ISLAND AVE., LONG ISLAND

93-D-7

CITY OF PORTLAND, MAINE
DEPARTMENT OF BUILDING INSPECTION

In checking your application to construct a 2-story frame cottage, 28' x 42' at the above named location we find that we are unable to continue processing your permit until further information is provided as follows:

Lot no 7 93-D-7 City Assessor's map
Melia College

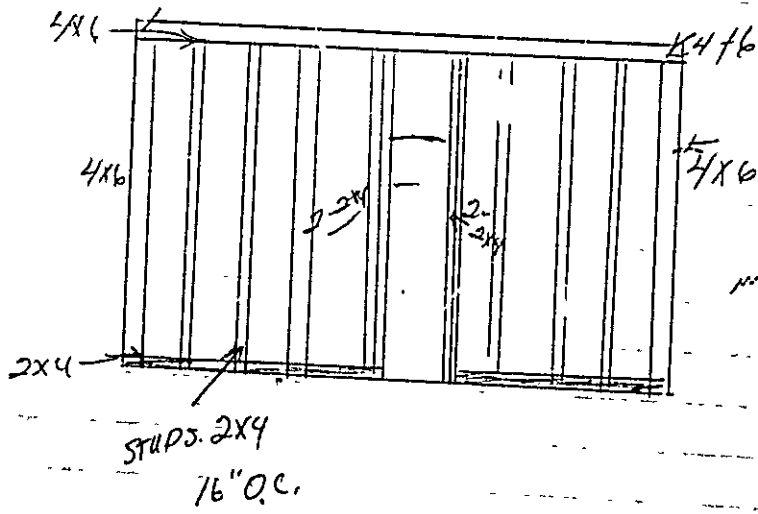
O.K. 2. We will need a plot plan showing the location of this cottage on the lot in relation to the front yard, side yard and rear yard setback. This plot plan will also need to show at least one parking space 8' x 18' located at least 25' from the front lot line.

2nd Floor

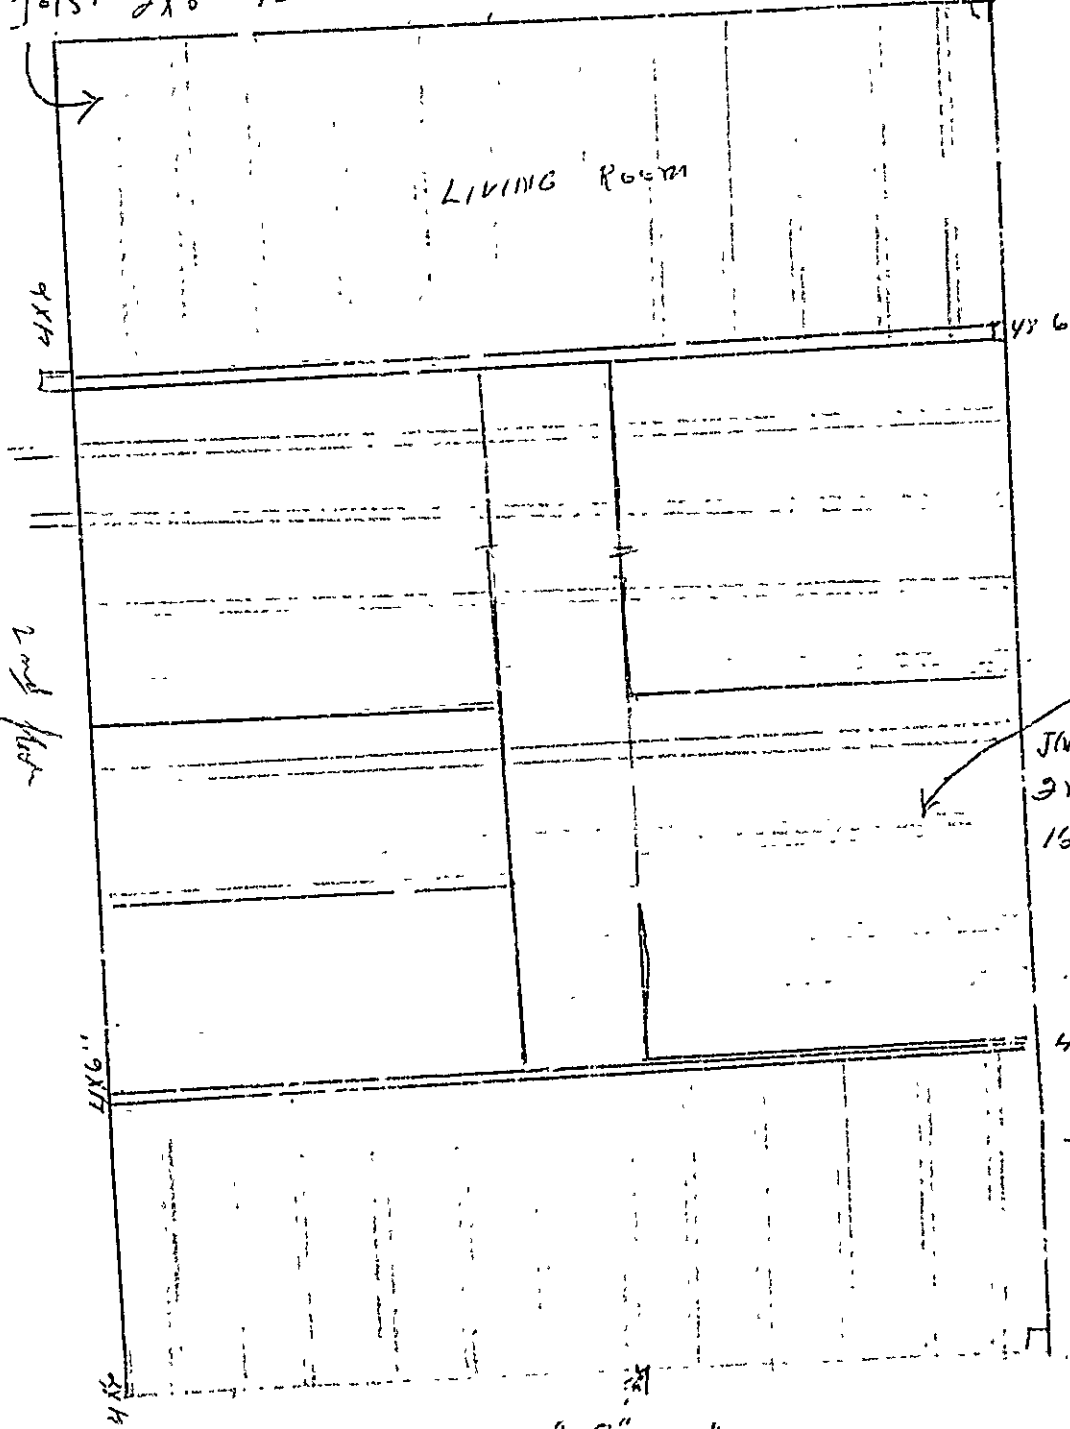
O.K. 5. The ridge will need to be supported by punchons down to the partitions directly beneath as shown on the second floor plan.

O.K. 7. The 2x8 inch second floor joists will need to be spaced at least 16" o. c. I would call to your attention however, although this is structurally sound a 2x8 on a 14' span will leave a little spring in your floor, however this is allowable under the Portland Building Code.

1st FLOOR

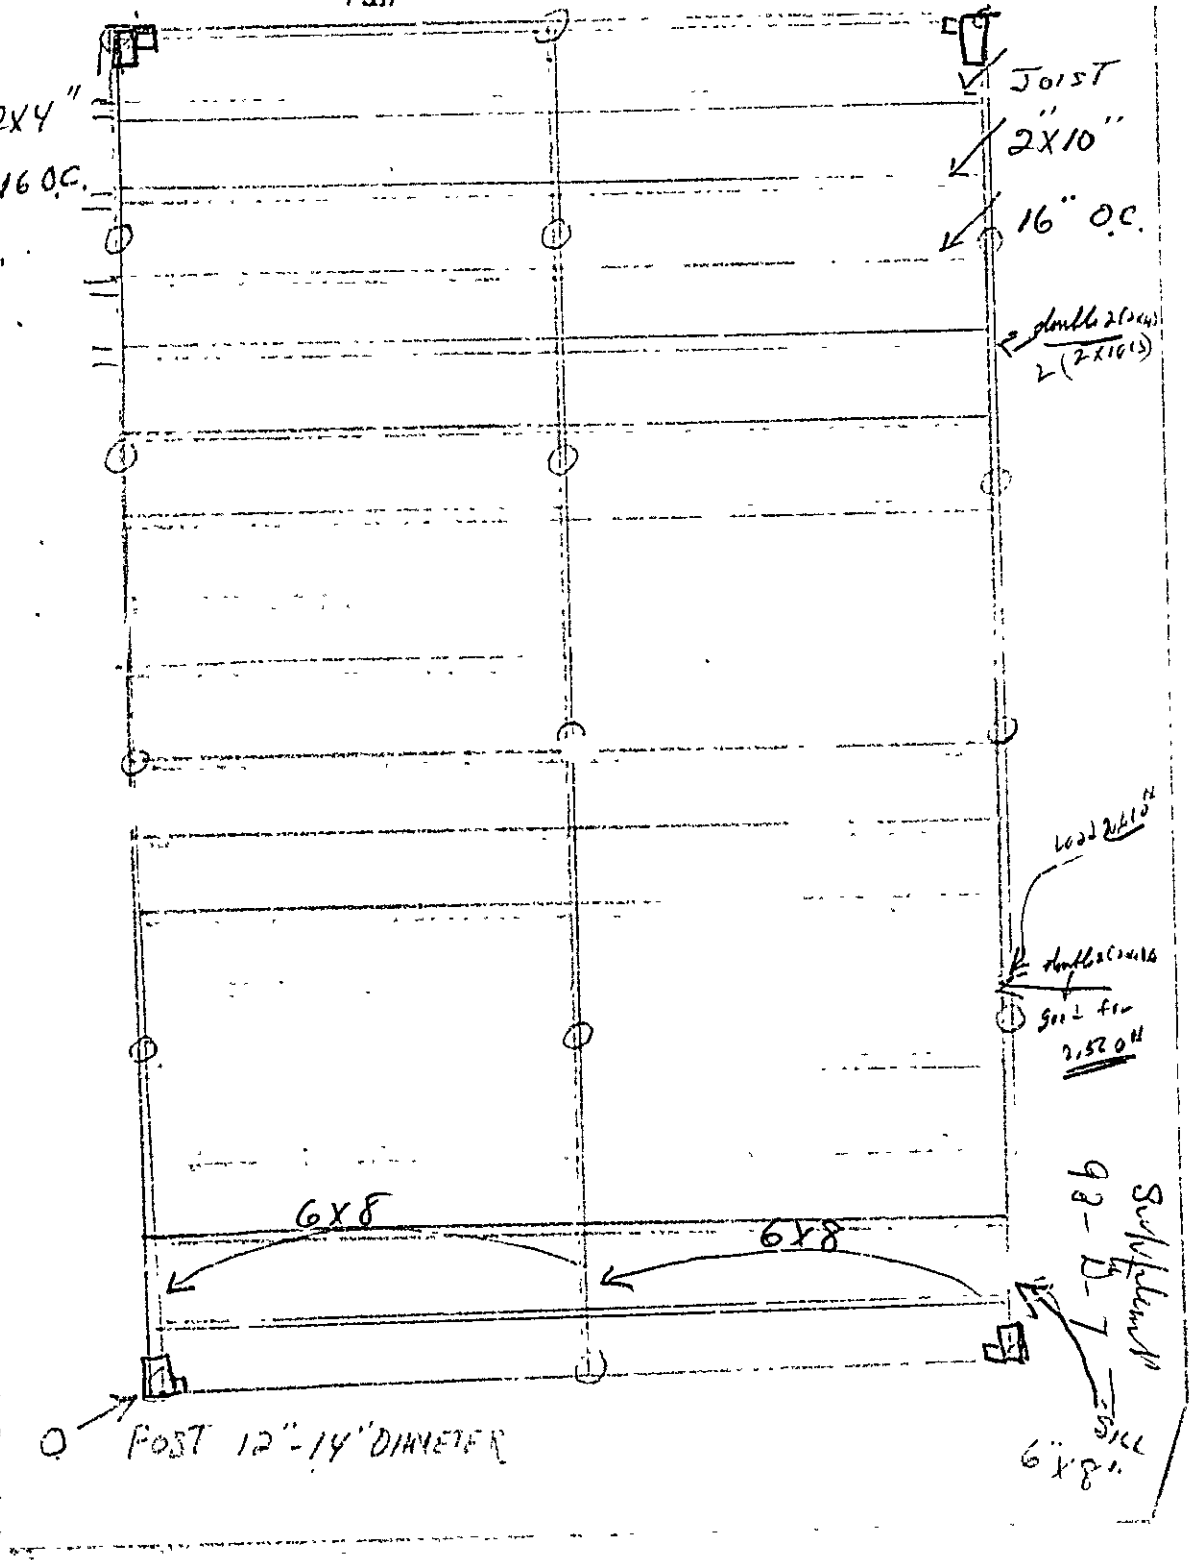
O.K. 4. We will need a new first floor framing plan showing how the partitions above are to be supported on the first floor between the living room area and T.V. and bedroom areas and at the other end of the cottage between the dining area and utility room and kitchen and bath are to be supported as this will also carry the second floor load as well as these walls. We will need to know what the girder will be and what the span will be between posts.

O.K. 9. Floor joists running parallel to non-bearing partitions and intended to support them shall be double wherever the net vertical area of the partitions 80 sq. feet or more and the span of the supporting joist is 10' or more. Double floor joists shall be provided on each side of the stairways.
